Re: Lots Road meeting to be held on 12th February 2003
Items for discussion

**Town and Country Planning (Environmental Impact Assessment)
 (England and Wales) Regulations 1999
 Lots Road Power Station, Lots Road London SW10**

TOWN AND COUNTRY PLANNING ACT 1990
TOWN AND COUNTRY PLANNING (ENVIRONMENTAL IMPACT ASSESSMENT)
REGULATIONS 1999
LOTS ROAD POWER STATION DEVELOPMENT
AMENDMENT TO PLANNING APPLICATION REF: 02/01324

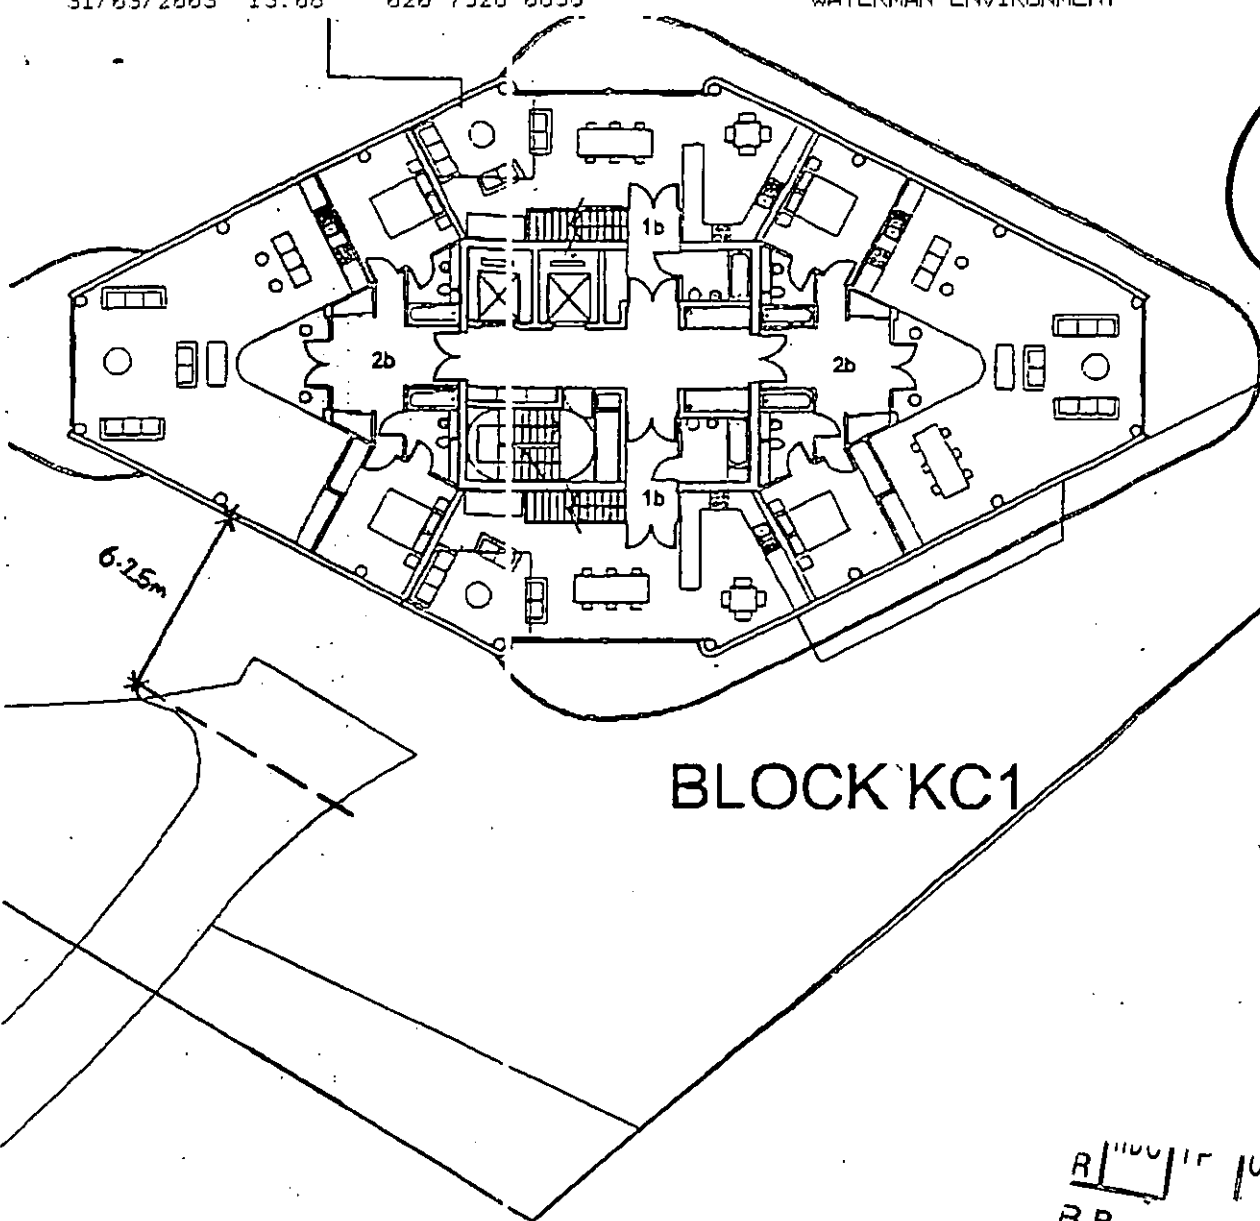
Point 5, I note your comment however, we would maintain that the river path is a minimum of 5m wide at all points. As discussed on the phone the only point where there is any possible restriction less than this is at the lighting columns that coincide with the line of the ventilation columns. We acknowledge that these can be staggered and their final position agreed as a planning condition. It is also possible that they can be positioned within the line of the safety barrier and therefore not narrow the path at all. I enclose a sketch illustrating the path width along the Thames.
